Date of Notice: (DD/MM/YYYY) **16/11/2017** Product Change Notice Number: **MEM2051 D PCN 20171116**

Product Identifier: **MEM2051-00-195-00-A**

Drawing Revision Letter: **D** Effective from date code/batch code: **Immediate effect.**

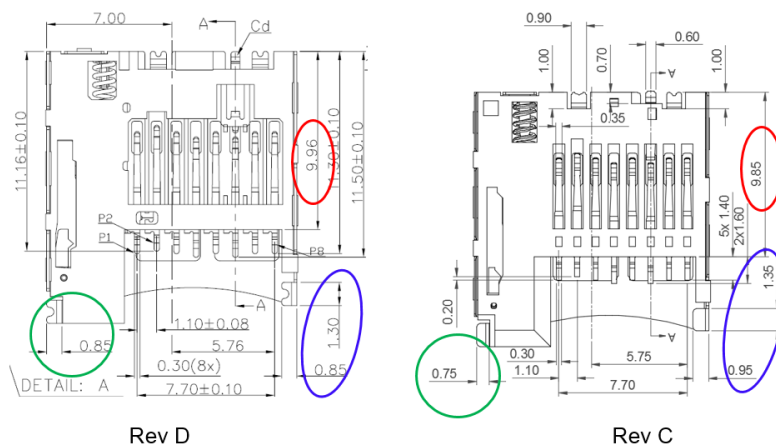
1. Minor dimension changes (**14.05 to 14.00**, **14.30 to 14.20**, **15.25 to 15.20**, **11.17 to 11.21**):

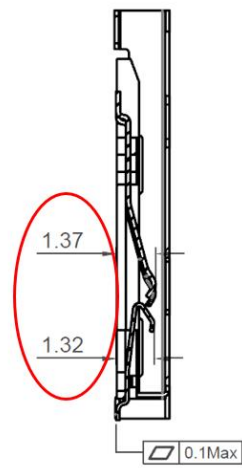
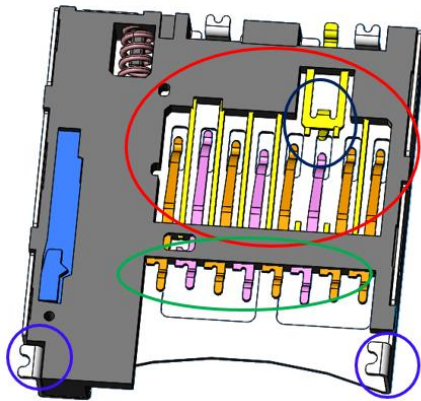
3. Change in contact height from 1.37 to 1.54 & 1.32 to 1.22:

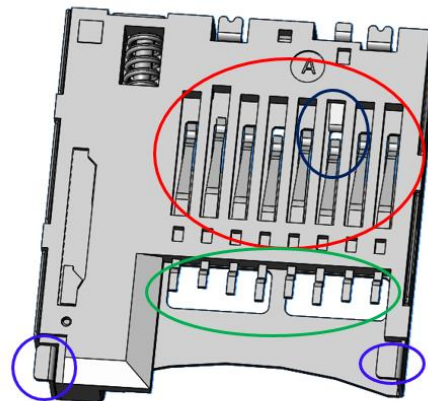
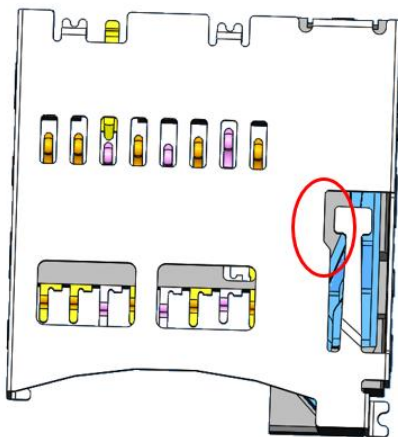
4. Change in housing & shell structure:

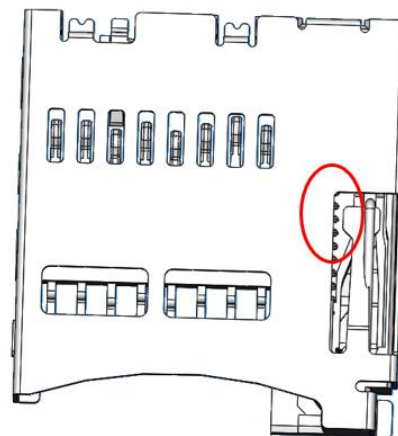
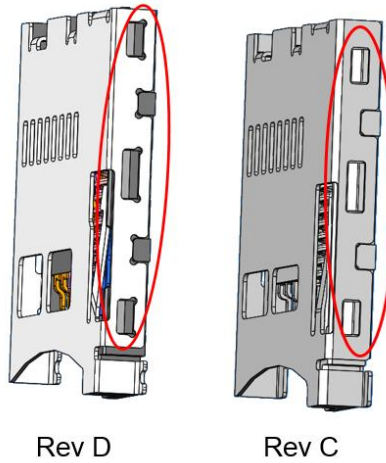
5. Change in shell structure:
